Rezoning and Development Plan: Botham Residential
CD-CPC-2023-00169 & CD-CPC-2023-00170

February 6, 2024

City Plan Commission

Rezoning

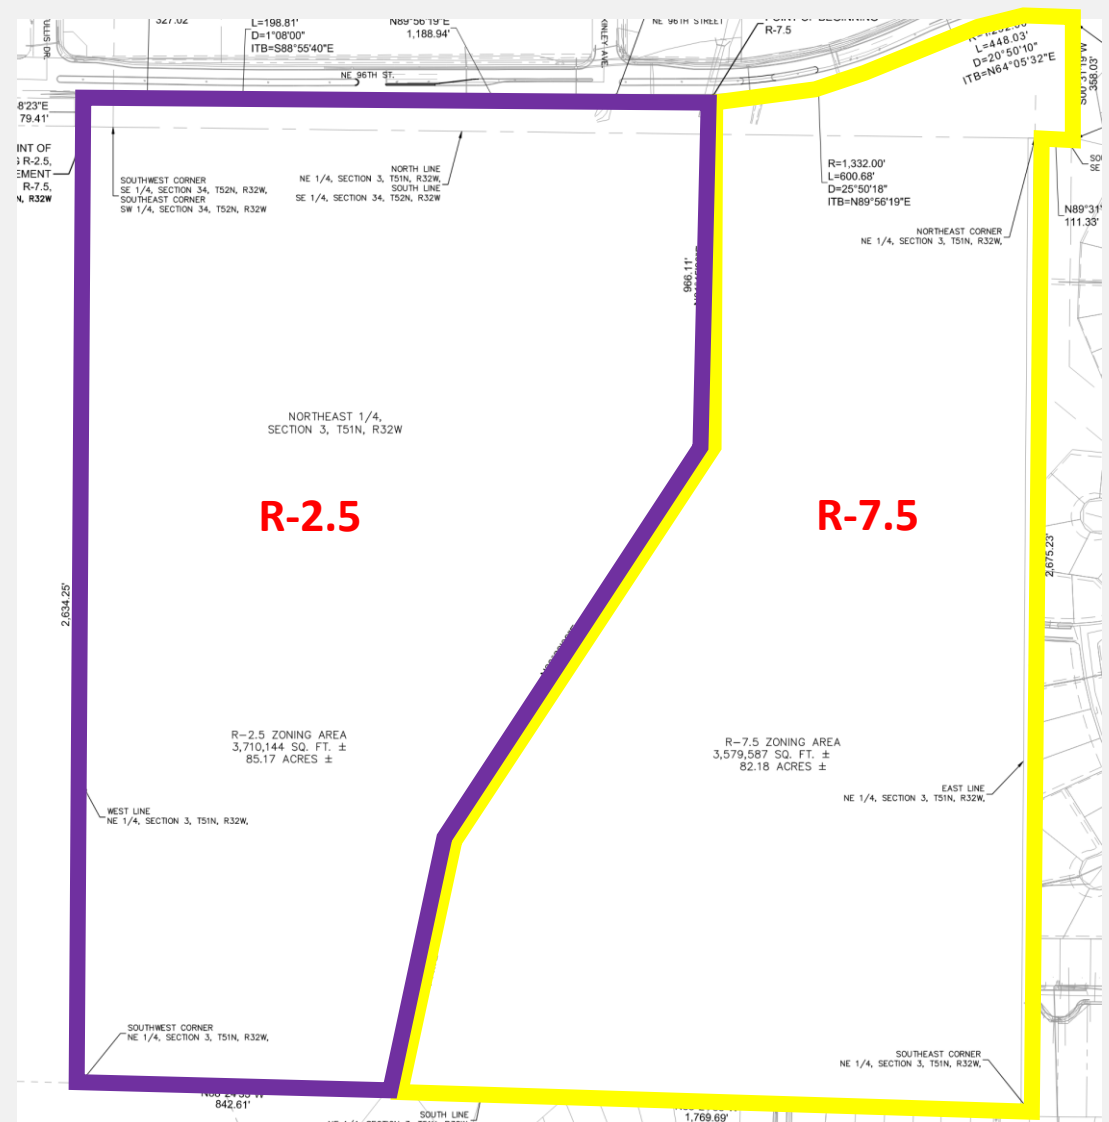
- **East** of Regulated Stream Proposed to be **R-7.5**
- Existing neighborhood to the east is zoned R-7.5
- **West** of Regulated Stream Proposed to be **R-2.5**
